HISTORIC AND DESIGN REVIEW COMMISSION

Agenda Item No: 24

HDRC CASE NO: 2016-266
ADDRESS: 458 FURR DR
LEGAL DESCRIPTION: NCB 6696 BLK 5 LOT 22 W 25 FT OF 23 E 25 FT OF 21
ZONING: R6 H
CITY COUNCIL DIST.: 7
DISTRICT: Monticello Park Historic District
APPLICANT: Eduardo Garcia
OWNER: David & Lydia Lerma
TYPE OF WORK: Window replacement
REQUEST:

The applicant is requesting a Certificate of Appropriateness for approval to replace 27 existing, including wood one over one, steel casement, and wood divided light windows with 27 new wood one over one windows.

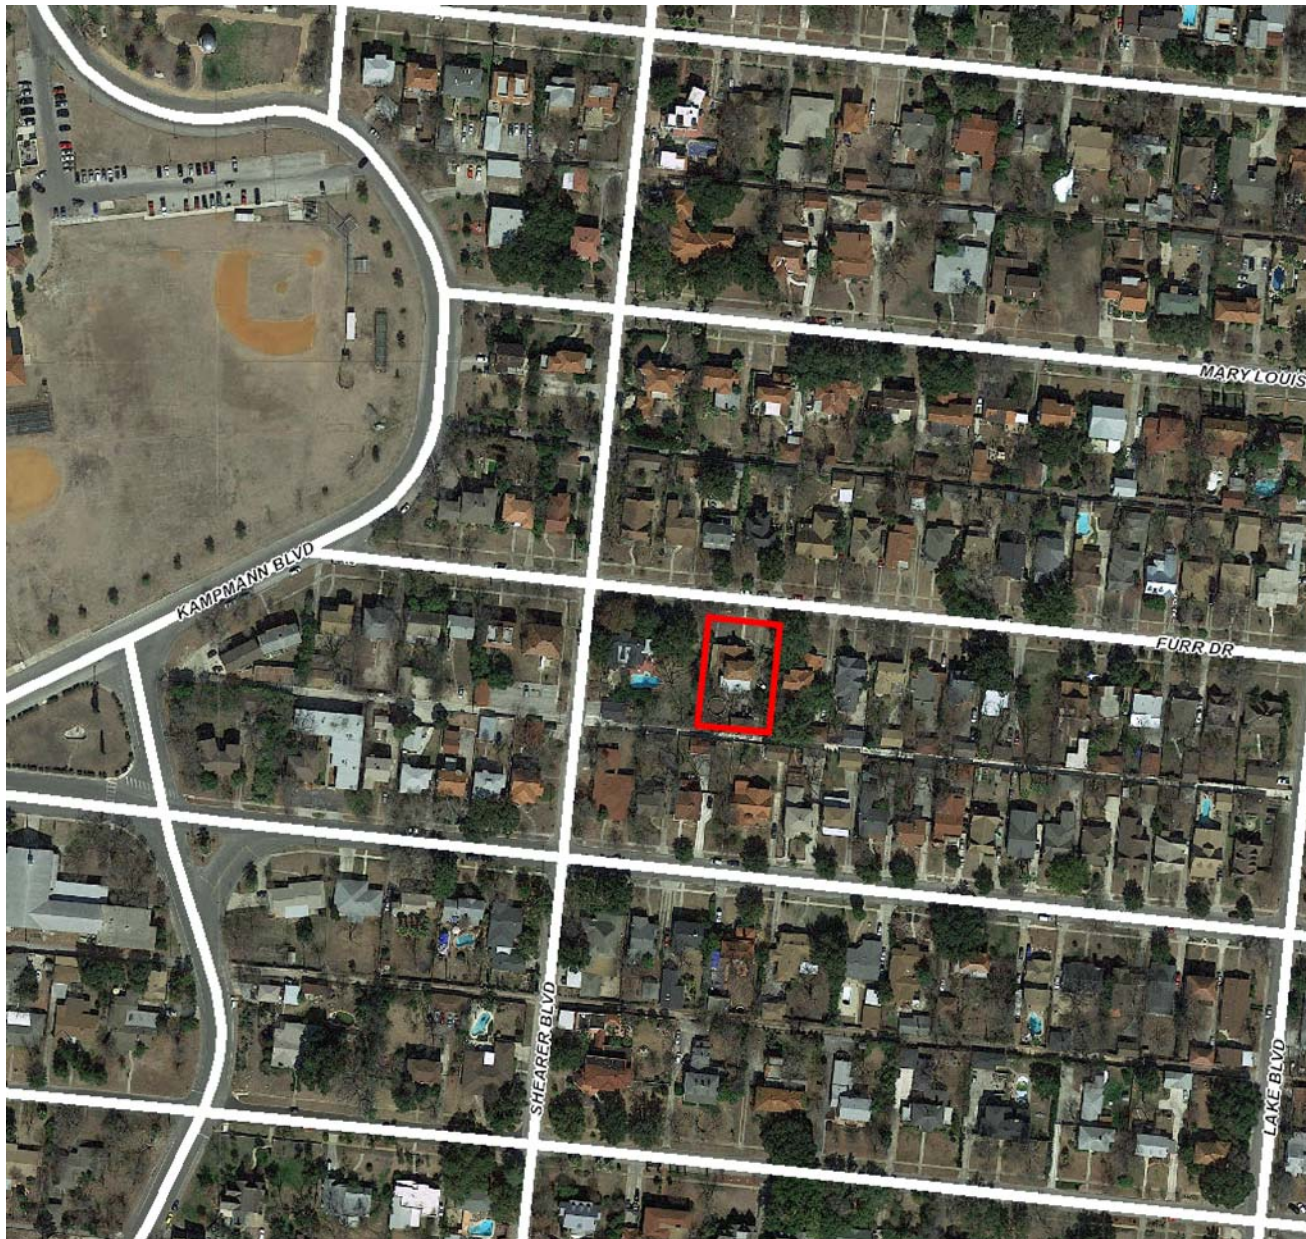
- a. The property at 458 Furr Drive is located in the Monticello Historic District, designated in March 23, 1995.
- b. Existing, there are 28 windows, including 13 wooden one over one, 5 double wood one over one, 5 wood with divided lights, 4 steel casement, and one picture. The applicant is proposing to replace 27 of the 28 windows with all wood one over one windows. There was a fire in the house; most windows are repairable and a few were damaged in the fire and are deteriorated beyond 50 %. According to the Guidelines for Exterior Maintenance and Alteration 6.B.iv., windows should only be replaced beyond repair. If beyond repair, replace with windows that match existing in terms of size type, configuration, material, form, appearance, and detail. Staff finds that the proposal to replace all windows not consistent with the Guidelines.

- c. Staff performed a site visit on June 29, 2016, and found that several of the windows are in good condition, including the wooden windows with divided lights and the steel casements. Staff recommends that 16 windows be repaired, and the remaining deteriorated 11 windows be replaced in-kind windows.

1. That the applicant repair 16 of the 27 windows with in-kind materials.
2. That the applicant replace 11 of the 27 windows with in-kind materials, type, configuration, form, appearance, and detail.

WINDOW
SCHEDULES

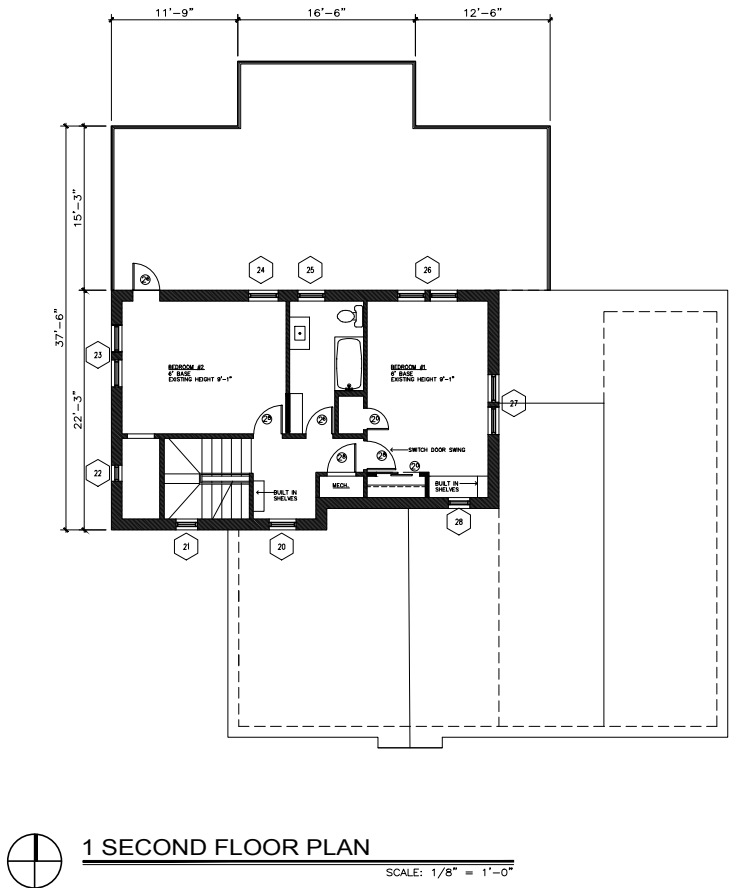
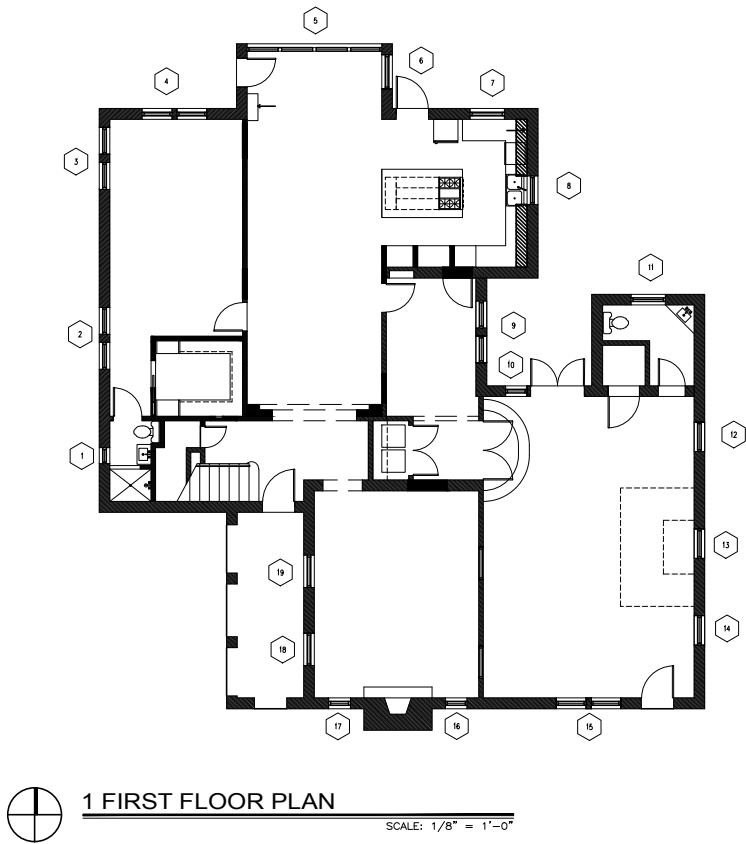
13. Repairable - wood 4 x 4 divided light with center casement

14. Repairable - wood divided light with center casement

16. Deteriorated over 50% - wood one over one with 4 over 4 wood screens

17. Deteriorated over 50% - wood one over one with 4 over 4 wood screens

18. Deteriorated over 50% - wood one over one with 6 over 6 wood screens

19. Deteriorated over 50% - wood one over one with 6 over 6 wood screens

20. Deteriorated over 50% - wood one over one

21. Deteriorated over 50% - wood one over one

22. Repairable - wood one over one

23. Repairable - double wood one over one

24. Repairable - wood one over one

25. Repairable - wood one over one triple hung

26. Deteriorated over 50%

27. Repairable - double wood one over one

28. Deteriorated over 50% - wood one over one
